Development Application No: DA2024/0895

Construction of a secondary dwelling at 15 Lido Avenue NORTH NARRABEEN.

D11.10 Landscaped Area

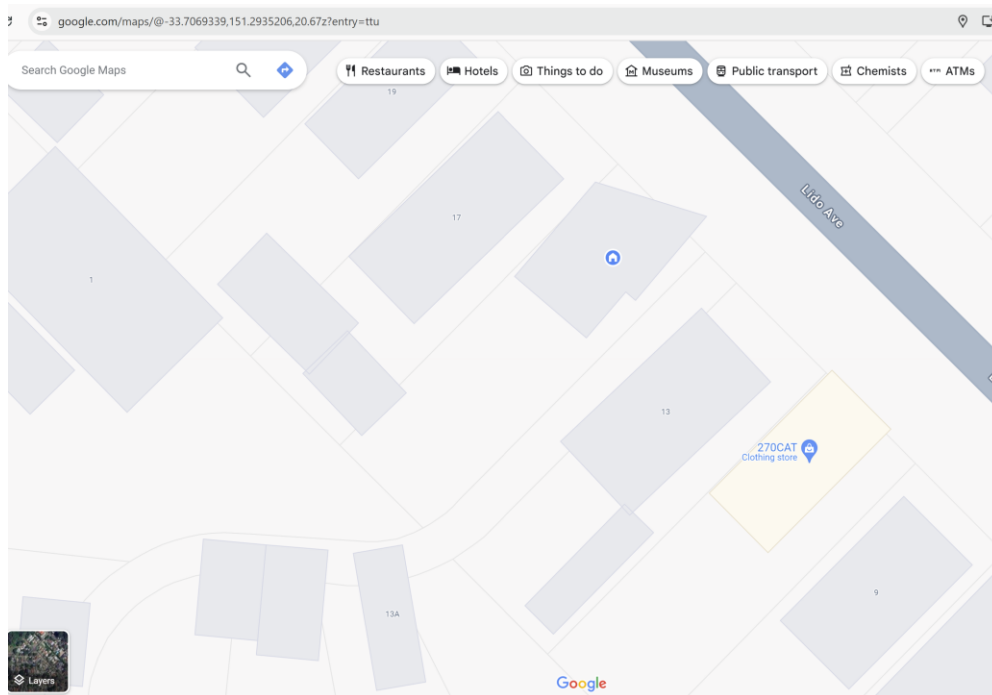
To be compliance with D11.10 we are removed the Alfresco from the project.

The project will have a minimum of 50% of landscape area as recommended.
